RE: Certificate of Appropriateness Application
BAR 16-10-05
206 West Market Street
Tax Parcel 330111000
Biarritz, LLC, Owner/David Ackerman, Applicant
Proposed Solar Panel Addition

**CITY OF CHARLOTTESVILLE
BOARD OF ARCHITECTURAL REVIEW
STAFF REPORT
October 18, 2016**

Proposed Solar Panel Addition

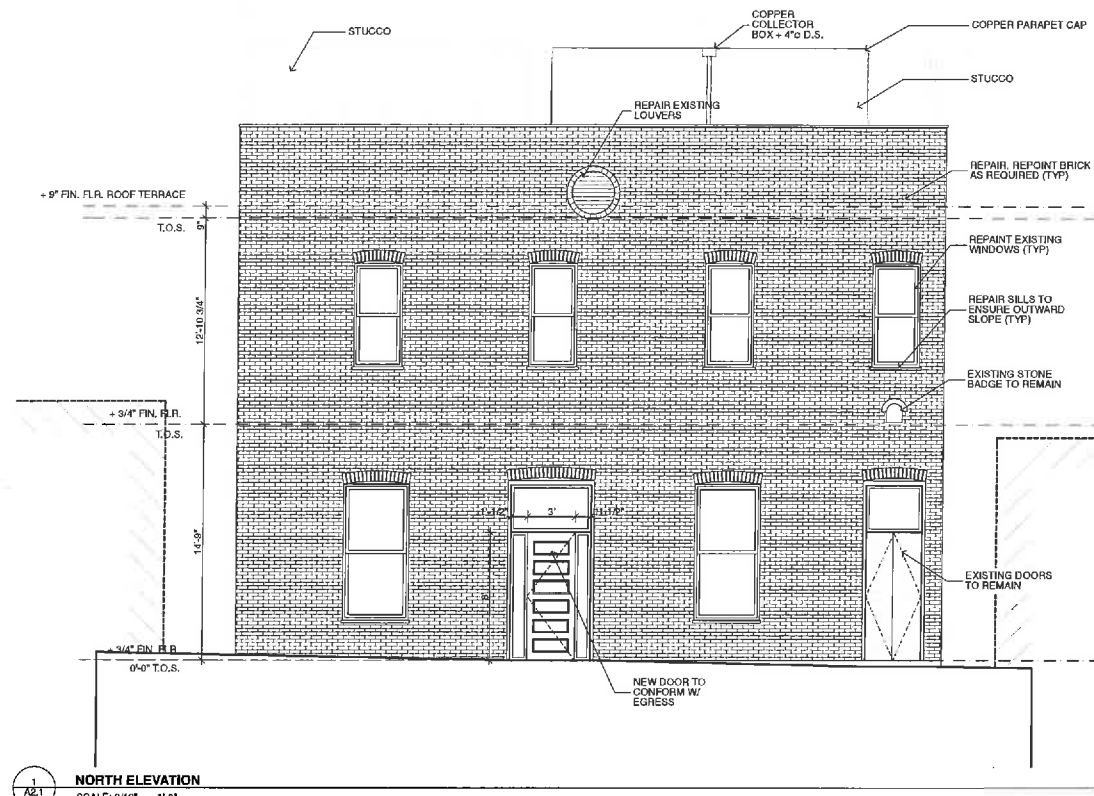
Will rain water go through the panels on the trellis, or how will it drain ?
How will the panels be attached to the trellis?

1. Rain will not penetrate the panels. The water will drain onto the roof deck.
2. The panels have an integrated aluminum wire raceway. This will be screwed to our aluminum purlins (see attached). Their drawing calls our support beam an aluminum channel, but it is steel.
3. That grey fill is an anomaly, it should register as existing brick. It does on my screen, but when I print it to a PDF, it gets weird and I cannot figure out how to fix it.

3 WEST ELEVATION
SCALE: 3/16" = 1'-0"

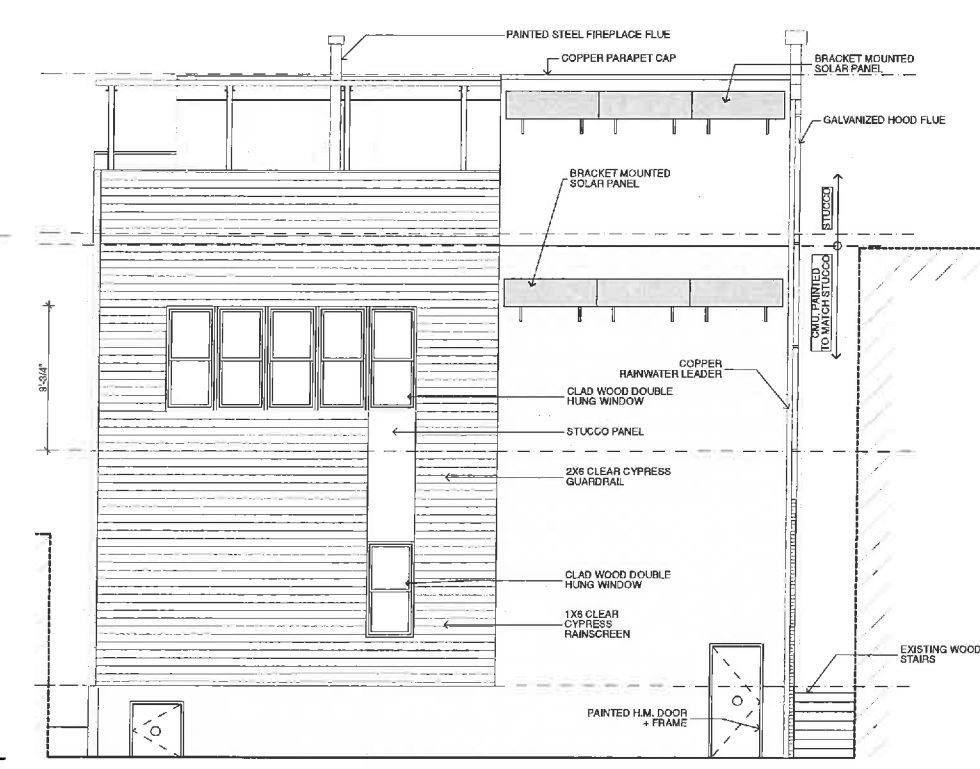
On the new drawings, west elevation, what material is the gray area behind the downspout? It is not rendered, but should be existing brick, correct?
